State of Utah
DEPARTMENT OF ENVIRONMENTAL QUALITY
DIVISION OF WATER QUALITY

May 13, 1992

RE: Jumbo Mining Pads and Ponds
Additional Information

DESIGN SCHEMATIC

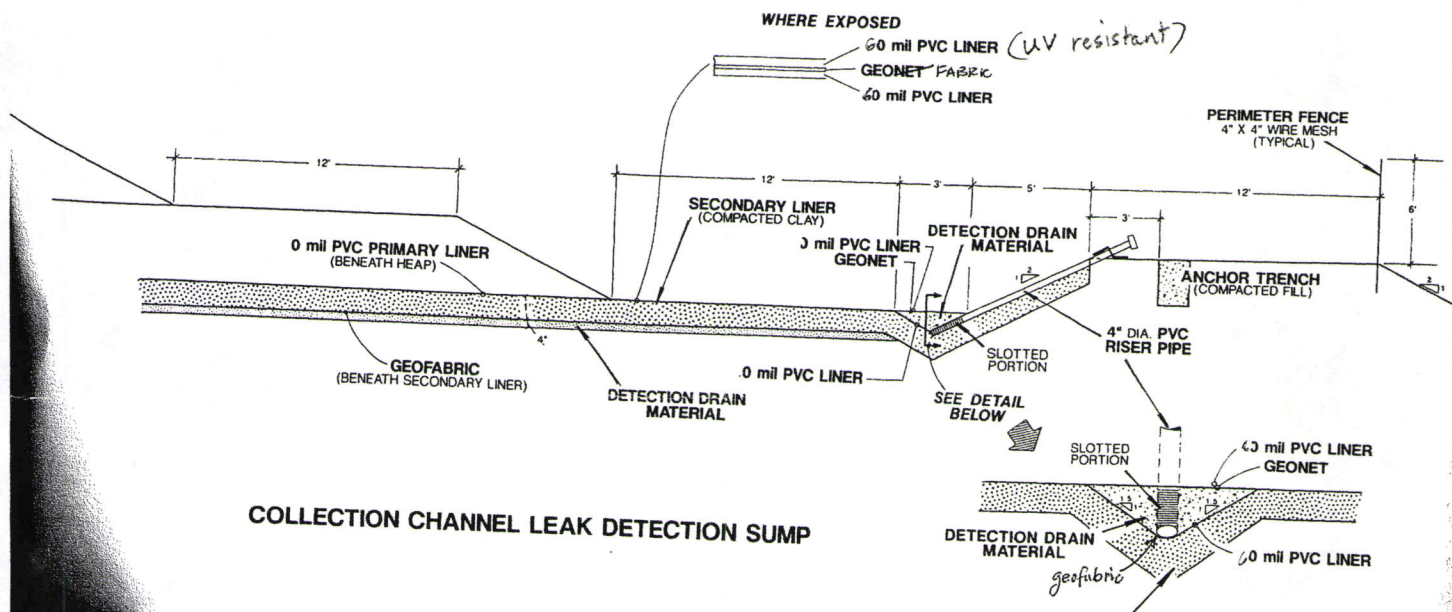
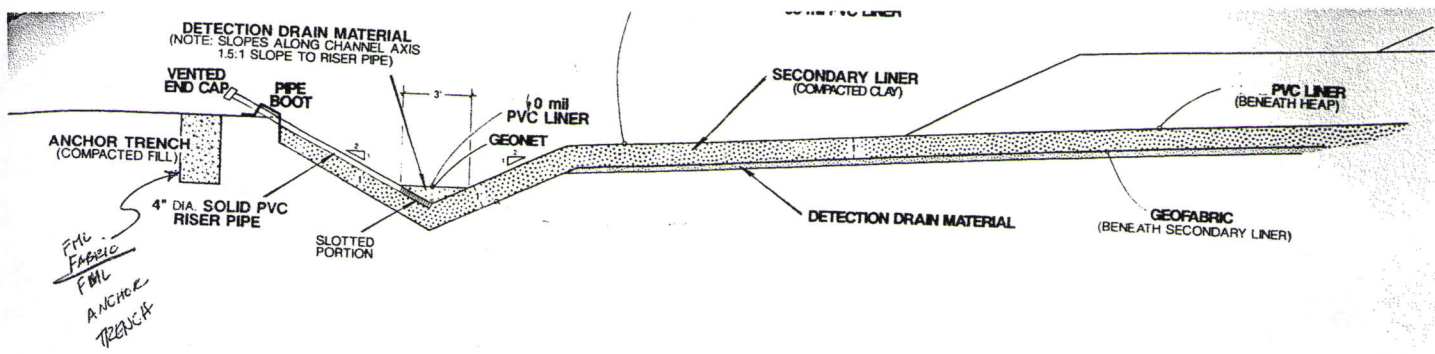
1. The minimal liner thickness is 60 mils.
2. A double lined perimeter with sumps to monitor perimeter leaks is required. A concept drawing is attached. These sumps with corresponding monitoring ports should be placed at approximately 150-feet on centers where solutions will be conveyed around the pad perimeter.
3. Settlement stand design for the pad was also discussed. Settlement stands are required to measure deflection in subgrade fill areas. If fill areas will exist, then stands would be required in cut areas for reference. Please submit a proposed layout, as applicable.

IN SOLUTION CONVEYING BOUNDARIES;
Sumps AT 150' O.C. \pm .
